2016/5975/L and 2016/5974/P 26 Christchurch Hill, London NW3 1LG

Construction of a basement extension under the modern wing of GII listed dwelling house (C3) and garden incl. demolition and rebuild of detached garden studio (C3).

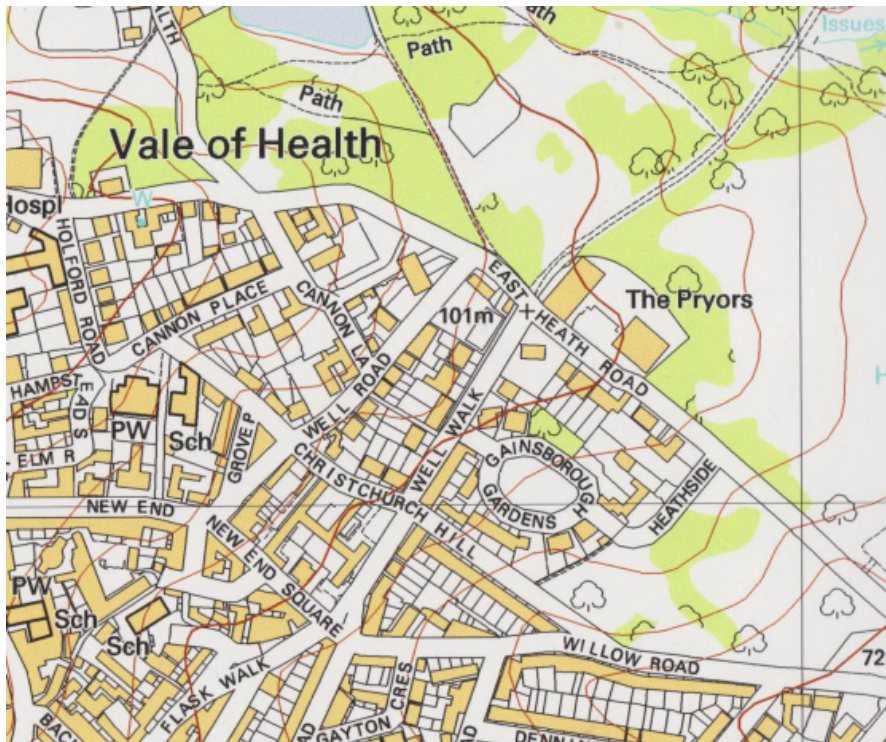
The GEA BIA report acknowledges that: 'The boundary between the Claygate Member and overlying Bagshot Formation is approximately 50 m to the northwest at a level of approximately 110 m OD, around 6.00 m above the level of the site.' The report fails to state the relevance of the dotted line here on the British Geological Survey map, and that it is a spring line. It is almost unbelievable that the answer to the second question from 3.1.1 'Subterranean (groundwater) Screening Assessment': "Is the site within 100 m of a watercourse, well (used/disused) or potential spring line?" is 'No'! This very partial desktop study completed by those who are unfamiliar with the conditions in Hampstead is completely inadequate.

Figure 3iii) Environment Agency updated Flood Map for Surface Water from 'London Borough of Camden Strategic Flood Risk Assessment 2014'.

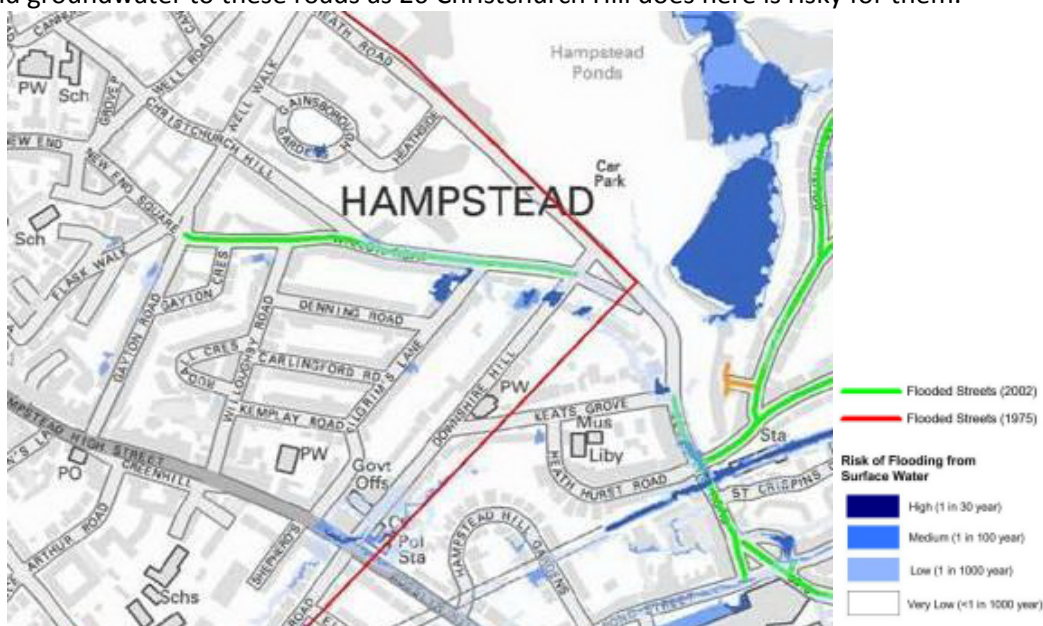
Coupled with evidence from the 'Flood map for surface water', this shows that while 26 Christchurch Hill might not be at high risk of flooding, many roads very nearby are. Any construction that affects the surface run-off and groundwater to these roads as 26 Christchurch Hill does here is risky for them.

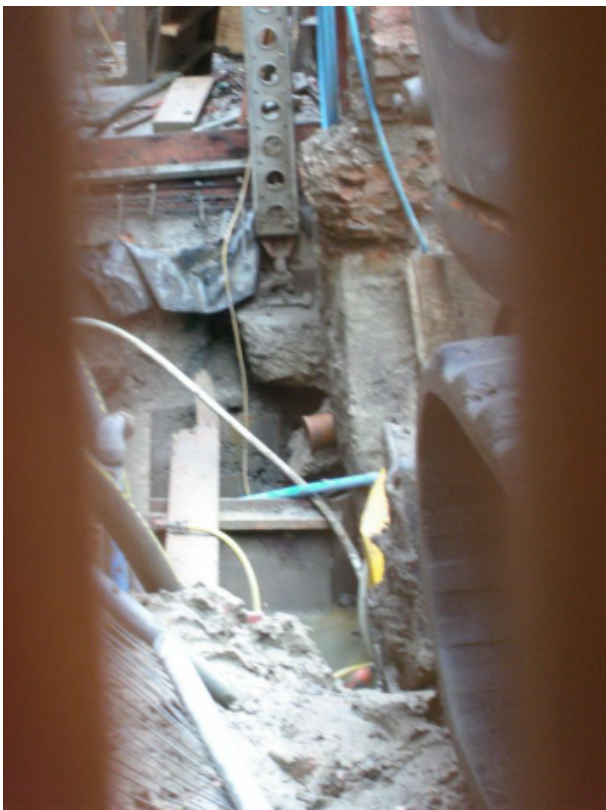
The key concern for this plot is that it is immediately 'up-stream' of its neighbour 22 Christchurch Hill that underwent a pretty catastrophic event during digging out of its basement. This event from 2007-9 is either unknown or ignored in this application.

The BIA report notes that: 'The neighbouring No 22 to the southeast of the site was granted planning permission for the excavation of a single level basement in June 2007.' However it fails to report that the basement dig here broached water under pressure in a sand parting, a lake rapidly formed under the house and there was immediate settlement of the building and its semi-detached neighbour requiring shoring up. The pictures below were taken some time after (December 2008) *while* 24 hour pumping was on-going.
